Access Compliance Report

Public Rights-of-Way

(Curb Ramps)

Intersection ID: 48634	Main Street: GRANDE_HEIGHTS_DR	Cross Street: DOMINION_CREST_DR	Location: NW
ADA ID: 770D3EB14CDD	Ramp Type: Perp	Initial Pass/Fail: Fail	Overall Compliance: No
Severity Score: 10			
Codes/Mitigation Info/Possible Solution		Field Measurements/Component Compliance

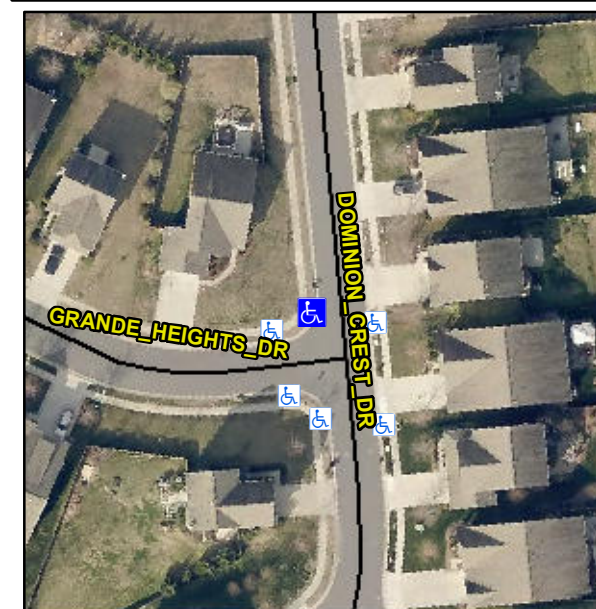
R304.5.1, R304.5.3

Compliance	Description	Data	Compliance	Description	Data
N/A	Ramp Length (in)	47.0	Yes	Ramp Slope (%)	5.6
No	Ramp Width (in)	47.0	No	Ramp XSlope (%)	4.1
N/A	Flare Type LT	N/A	N/A	Flare Type RT	N/A
N/A	Flare Slope LT (%)	N/A	N/A	Flare Slope RT (%)	N/A
N/A	Flare Traversable LT?	N/A	N/A	Flare Traversable RT?	N/A
N/A	Landing Length (in)	N/A	N/A	DWS Provided?	N/A
N/A	Landing Width (in)	N/A	N/A	DWS Contrast?	N/A
N/A	Landing Slope (%)	N/A	N/A	DWS Length (in)	N/A
N/A	Landing X Slope (%)	N/A	N/A	DWS Full Width?	N/A
N/A	Landing Curb? (Y/N)	N/A	N/A	DWS Offset (in)	N/A
N/A	Shared Landing?	N/A			
N/A	Gutter Ponding?	N/A	N/A	Gutter Slope (%)	N/A
N/A	Gutter Lip Ht (in)	N/A	N/A	Gutter X Slope (%)	N/A
N/A	Painted X Walk1?	No	N/A	Painted X Walk2?	N/A
	X Walk 1 Direction	To E		X Walk 2 Direction	N/A
N/A	X Walk 1 Width (in)	N/A	N/A	X Walk 2 Width (in)	N/A
	X Walk 1 Slope (%)	4.1		X Walk 2 Slope (%)	N/A
	X Walk 1 X Slope (%)	1.9		X Walk 2 X Slope (%)	N/A

Remove & Replace Entire Ramp.
